E5070A-05C

S E R V I C E N O T E

E5070A ENA Series Network Analyzer, 300 kHz to 3 GHz

Serial Numbers: JP1KJ00000 to JP1KJ00139

Figure 1. Trace shows noise around 1.3 GHz to 2.1 GHz at preset setting.

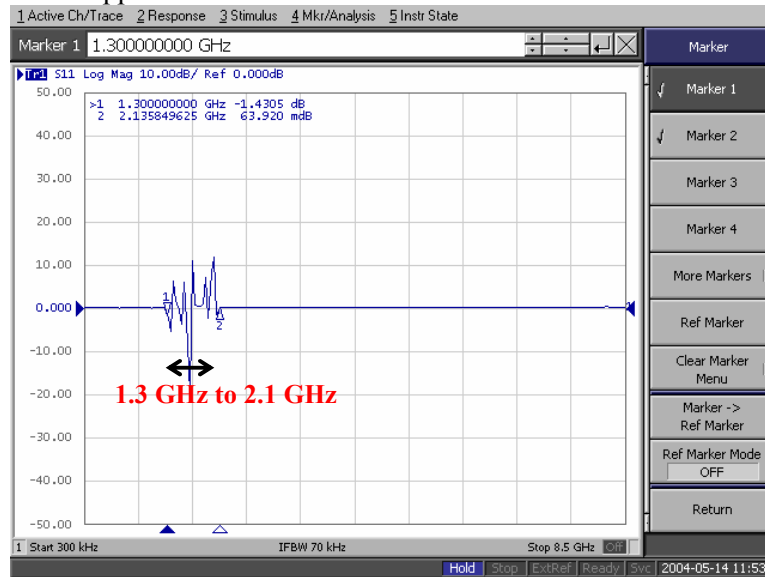
When the high-failure rate part has defective, the unit cannot output correct power level source or local signal, between 1.3 GHz and 2.1 GHz frequency range.

- The trace shows spike at 1.3 GHz or 2.1 GHz at the preset situation.
- The trace between 1.3 GHz to 2.1 GHz is more noisy than other frequency ranges.
- The power level of 1.3 GHz to 2.1 GHz is lower than other frequency ranges.
- Internal test of A1 ALC shows fail at SOP (f=1.3G) or LOP (f=1.3G) as Figure 2.

Above symptoms tend to appear after 30-minute heat run.

When a measurement trace or output power shows troubles between 1.3 GHz and 2.1 GHz, or in full frequency range, replace A1 module with the latest one (E5071-6x571), and update E5070A Operating System at the same time.
